**ISSUE:** Permit to Demolish/Capsulate (partial) and Certificate of Appropriateness for alterations and painting of unpainted masonry

**APPLICANT:** EAHG Alexandria LP

**LOCATION:** Old and Historic Alexandria District  
625 First Street and 510 Second Street

**BAR #2021-00470 & BAR #2021-00471**  
**625 First Street and 510 Second Street**

Figure 1: Building phases

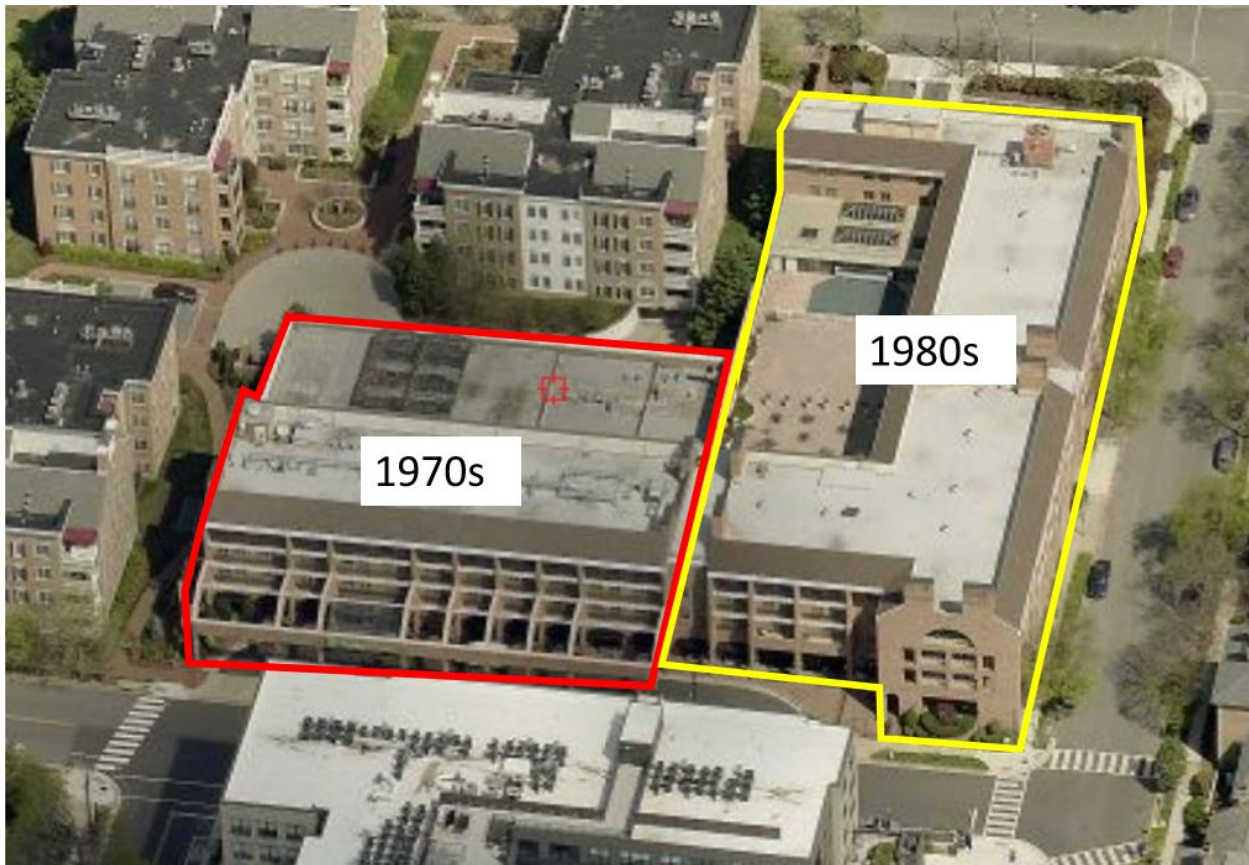
The hotel at 625 First Street has frontage on both First and N. Pitt Streets and was constructed in two phases. The first phase of the building was constructed as an addition in the **late 1970s** as part of the Old Colony Inn, which once occupied this site as well as the land to the west and north. The second phase of the hotel was constructed in the **mid-1980s** when the larger portion was constructed fronting on N. Pitt Street (Figure 1).

BUILDING ELEVATION SOUTH

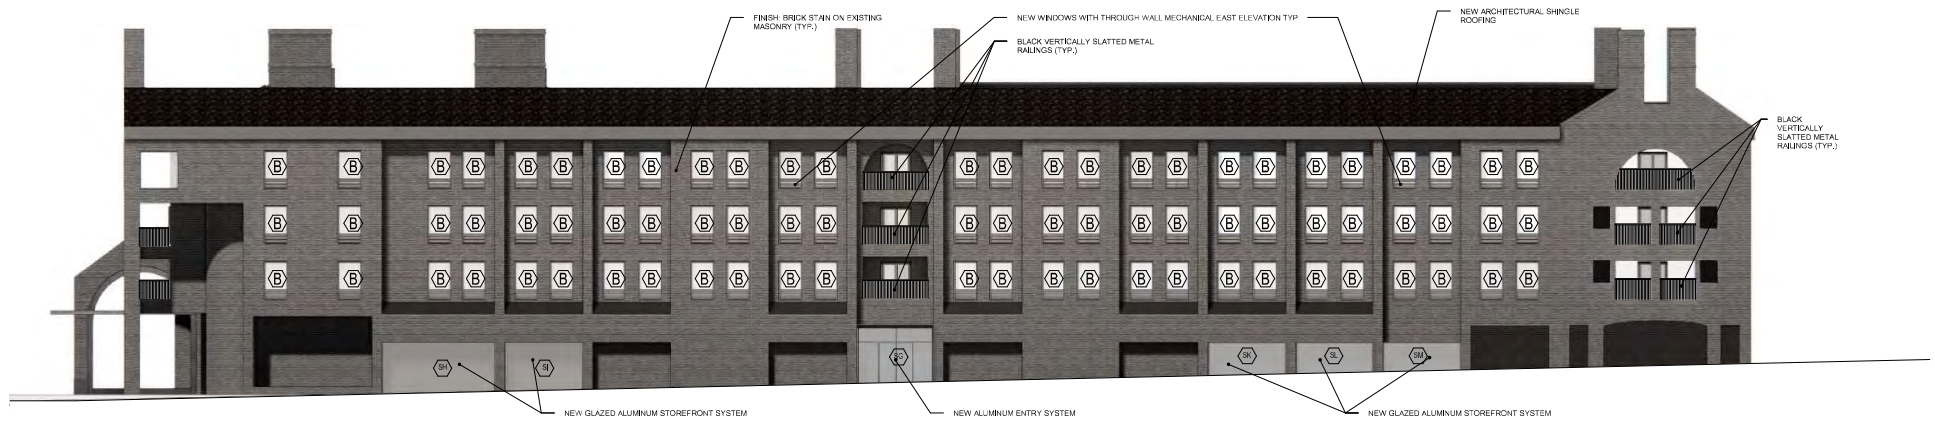
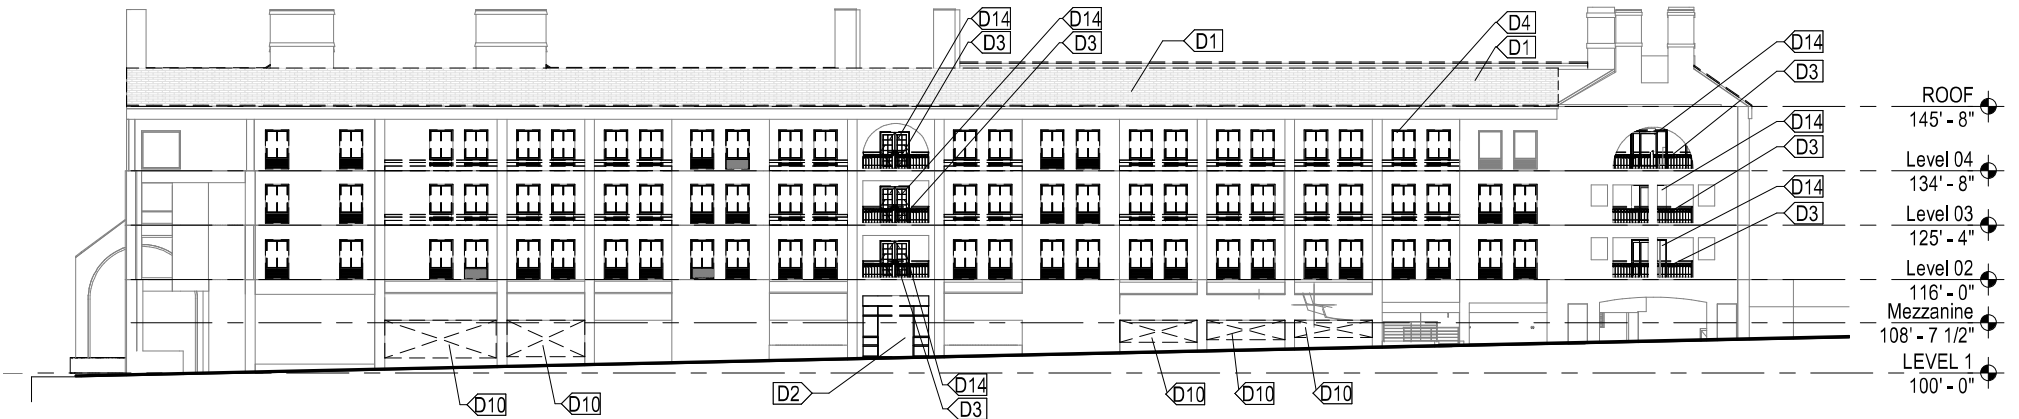
Your proposal to paint the brick exterior of the buildings dark gray generates, by far, the greatest change in the external appearance of the property. So, although this is our only objection to the project, it is not trivial. We have spoken with several of our neighbors, and we are prepared to elevate our concerns. However, we sincerely hope you resolve this issue by voluntarily committing to a lighter shade for the bricks in the spirit of being good neighbors.

Several residents of North Old Town have contacted me regarding the proposed color change to the building at 625 First Street. The proposal indicates that the brick structure will be painted black. Further, the proposal states that this color is consistent with the color of the building opposite on First. The building opposite on First is constructed predominantly of unpainted tan brick. Black is only an outlining color on that side of the building. Substantial black surfaces are on the interior facings of the building largely visible from North Pitt Street. Black is also not a significant part of the palate of the townhouses on North Pitt Street that are immediately east of the hotel building. Those townhouses are all unpainted brick or stucco. We do not see solid black walls as a good color for this community. A solid black building of this size would produce a jarring appearance, not one that works with the existing architecture.

The applicant initially stated in the project narrative that the building would be painted black; however, the proposed color - Benjamin Moore RAL7022 – is grey with olive undertones as shown in the color swatch below (Figure 2).

While the ordinance references “color” in the *Standards* for consideration, it is the Board’s long-standing policy to review paint colors only when associated with new construction. The *Design Guidelines* chapter on painting includes only two guidelines with respect to painting: “Structures should be painted a color appropriate to the historical period of the architectural style” and “Day-glow, neon and metallic colors as well as the color purple are inappropriate in the historic districts and the application of these colors alters the architectural character of the building.” In the opinion of staff, the proposed painting of the unpainted masonry building is “appropriate to the historical period of the architectural style” of the structure. For this structure, the issue of what color the building should be painted is more a matter of preference than an issue related to historic preservation. Fortunately, a painted building can easily be repainted any color relatively easily and with little expense.
